Cracked Or Broken Flexplate On 1990-1996 Ford 4.0L VIN X Engines

The AERA Technical Committee offers the following information on cracked or broken flexplates on 1990-1996 Ford 4.0L VIN X engines. It has been reported that some vehicles equipped with an automatic transmission may exhibit an unusual noise or vibration during cranking. This condition may be caused by a cracked flexplate.

Old (Left) and New (Right) Flexplate Designs

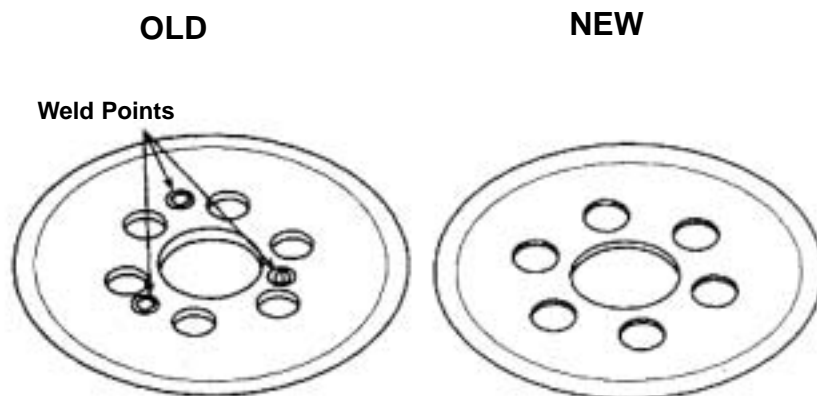
To help reduce the possibility of this type of failure, Ford has redesigned the flexplate and offers it for replacement with Part number F1TZ-6375-BA. The revised flywheel has increased strength in the area where cracking is most common as shown below.
